***MODIFICATION REQUEST:
NorthConnex Modification 2***

***Modification to Condition B2 -
Ventilation Outlet Heights
SSI 6136 (MOD 2)***

Environmental Assessment Report
Section 115ZI of the *Environmental
Planning and Assessment Act 1979*

Figure 2. Updated visual catchment mapping of the proposed tip height increased of the northern ventilation outlet (Source: Proponent's Modification Request)

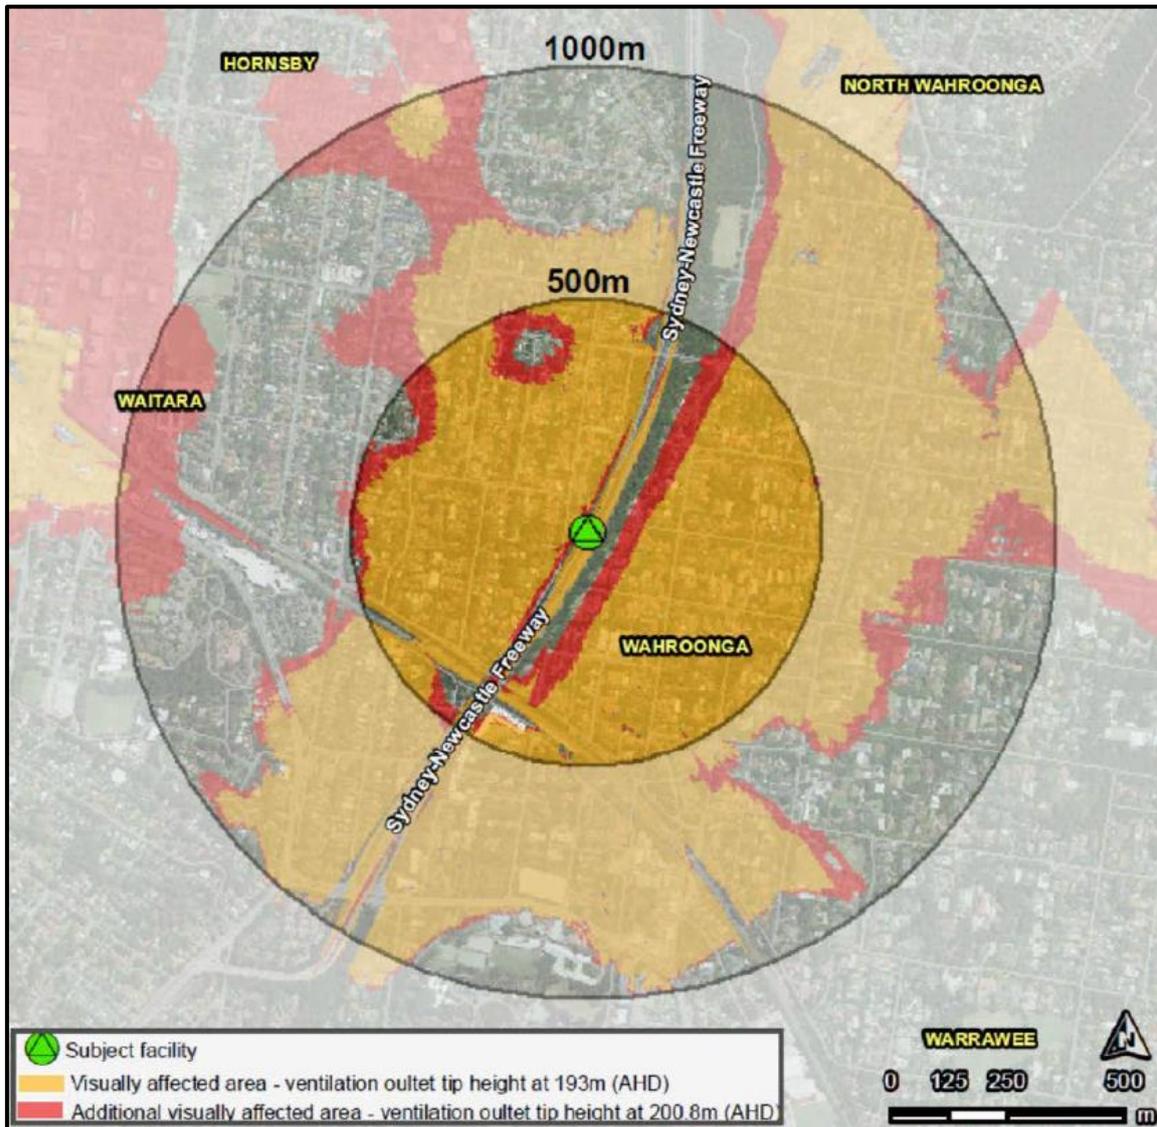
The proposed increased height of the northern ventilation outlet means it could potentially be seen by a greater number of receivers in the visual catchment compared with that assessed in the EIS or PIR.

Consistent with the EIS, the Proponent has assessed the visual impacts of an increased outlet height for a visual catchment of up to one kilometre surrounding the northern ventilation outlet. **Figure 2** indicates the areas where additional receivers may be able to see the higher ventilation outlet.

The Department acknowledges that increasing the height of the northern ventilation outlet by 6.8 metres above that approved for the original project would make it visible from more vantage points. However, it is also acknowledged that the catchment presented in **Figure 2** is based on topography alone and does not take into account potential obstructions such as vegetation or buildings. As such, the Department considers this approach to be conservative.

Whilst a greater number of receivers may be able to view a higher outlet, this impact is likely to diminish or be obscured with increased distance. Additionally, it is likely that any views beyond those receivers immediately adjacent to the site of the outlets will be partial. The Department considers that the urban design treatments to be applied to the ventilation facilities will assist in mitigating visual impacts.
